June 28, 2019

Response to City of Oregon City's Geotechnical Review Comments
Geologic Hazards Development Permit
Forest Edge Apartments
Oregon City, Oregon
GeoDesign Project: RJLHold-1-01

Date: June 24, 2019
To: Josh Wheeler, P.E.
Development Projects Manager
City of Oregon City
From: Timothy J. Pfeiffer, P.E., G.E. 
Subject: Geohazards (Chapter 17.44) Completeness Review (#2)
Project: GEO 19-01, PR-126-2019 - Forest Edge Apartments
Tax lot 3s2e04c - 807
Project # 2172001 (202)

Water Levels - Lower Campus

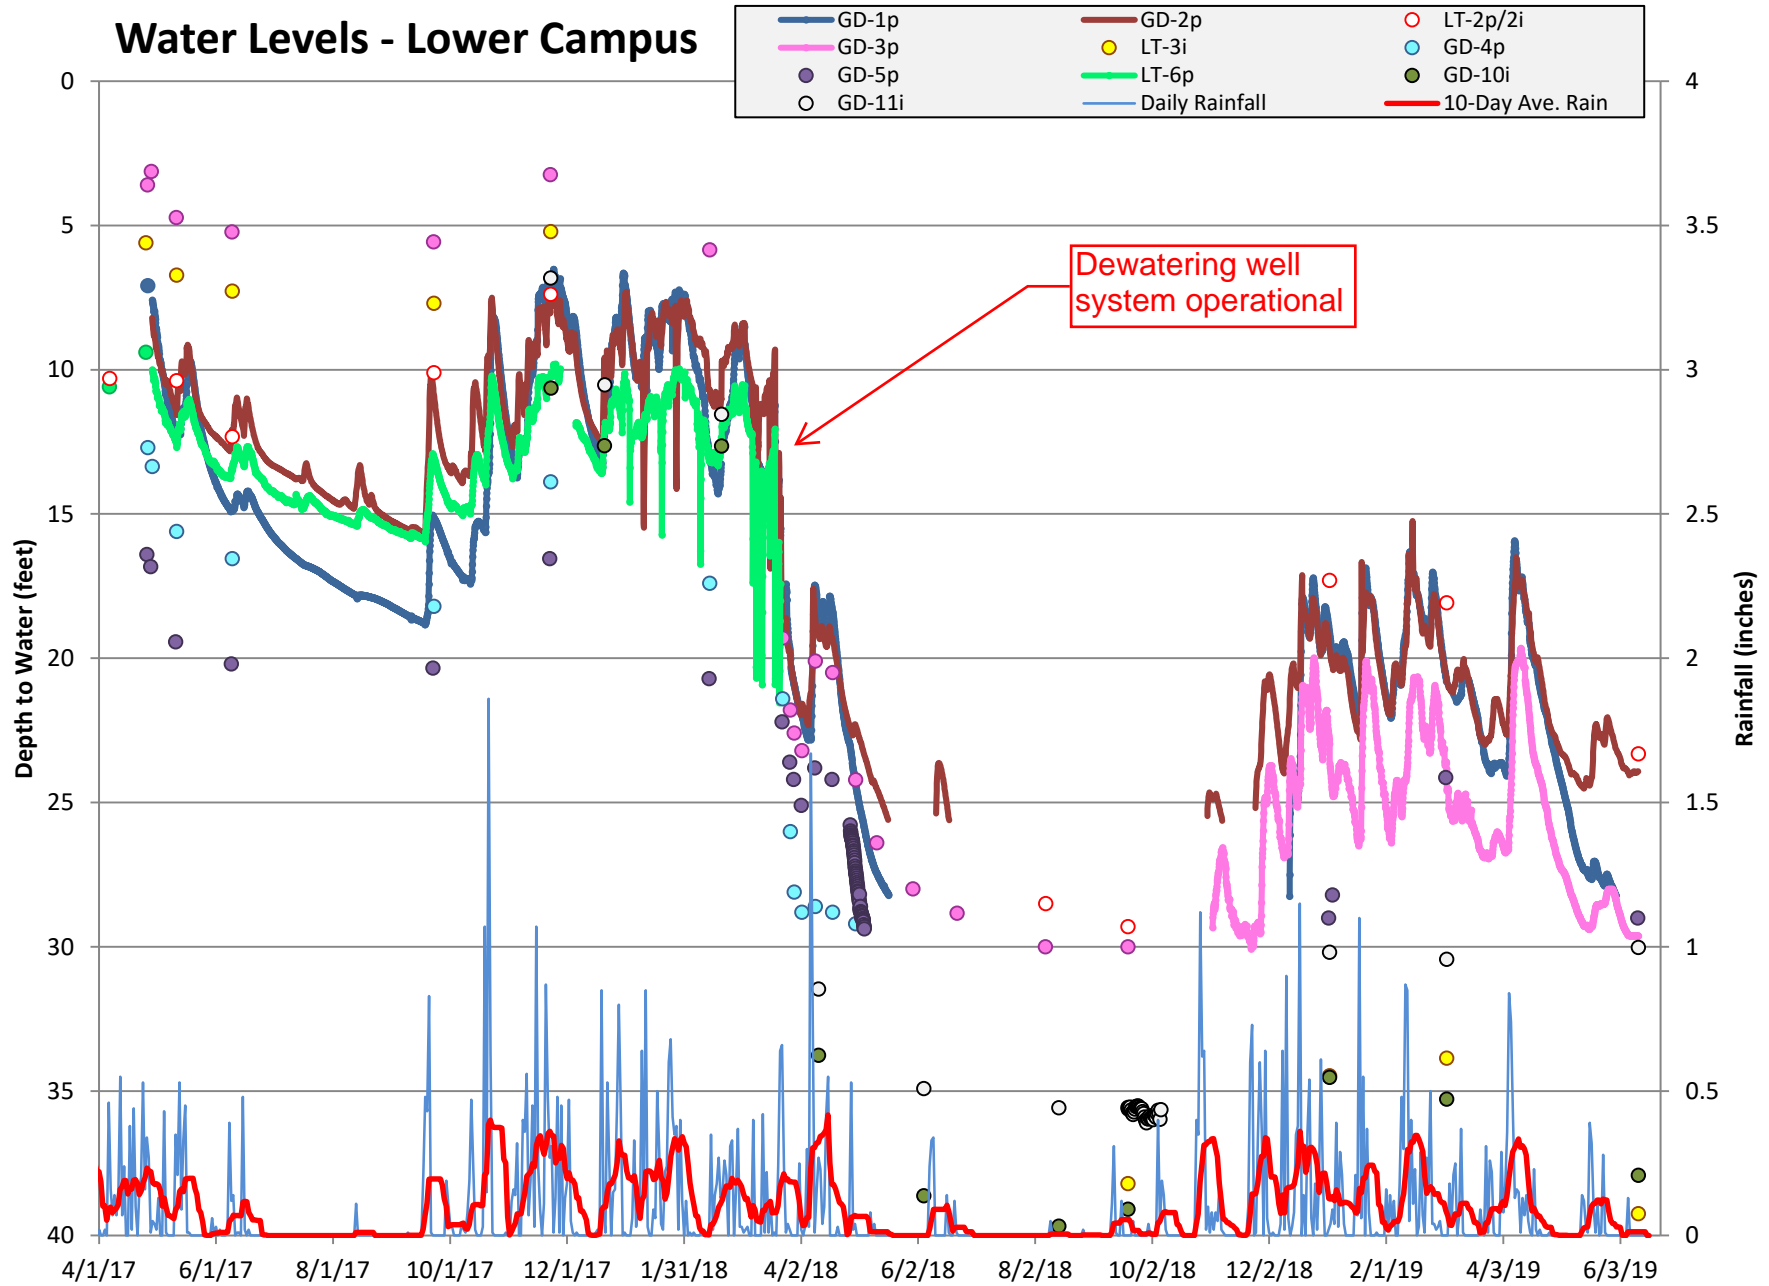
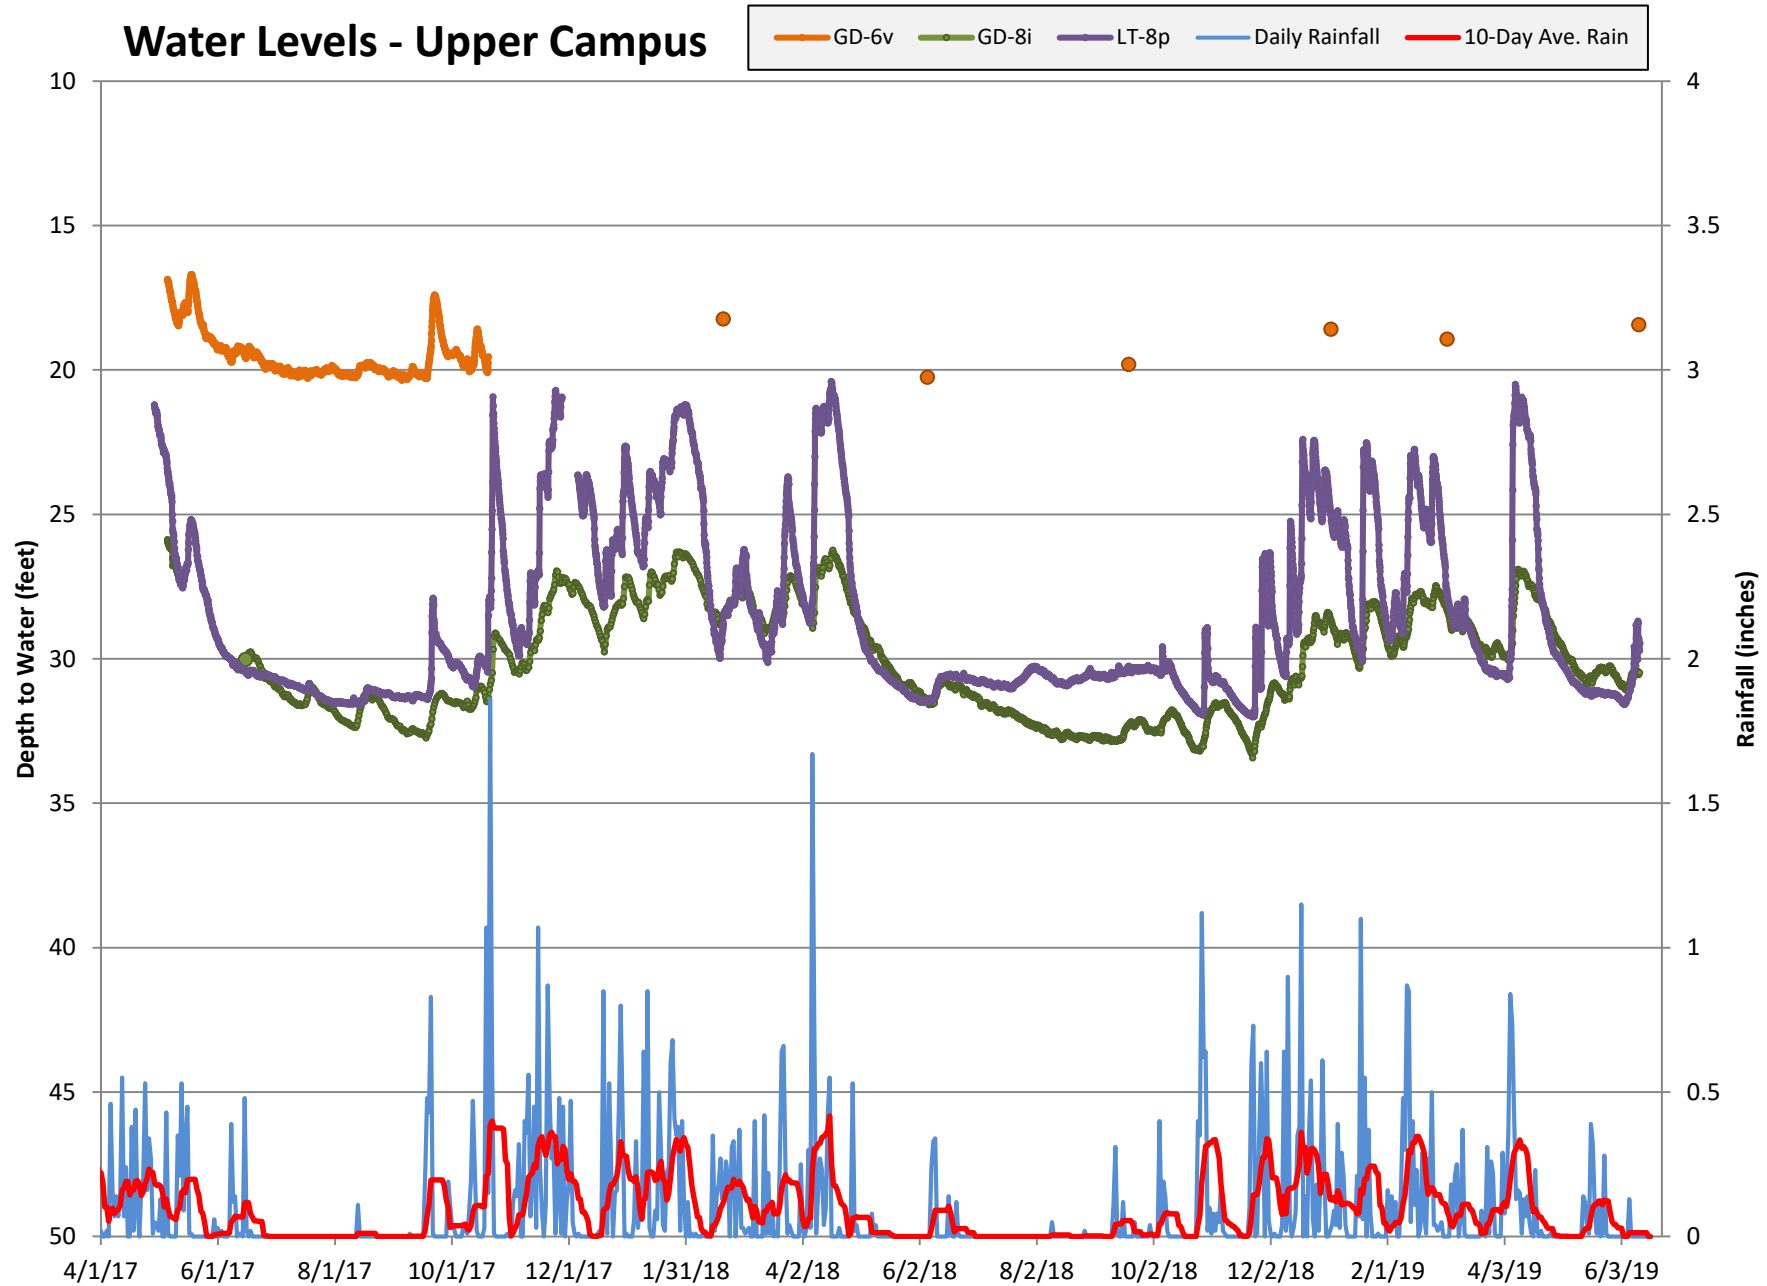
We provided an update to inclinometer and water-level monitoring data in our March 2019 supplemental report. As of March 2019, water levels were significantly lower than previously recorded natural water levels (i.e., levels unaffected by the dewatering system), and inclinometers showed no significant displacements since January 2019. We collected another round of monitoring data on June 13, 2019. Those data indicate that water levels continue to be

depressed by the dewatering system, and the inclinometers continue to show no significant displacements. Summary plots of the water levels and inclinometers are presented in Attachment B.
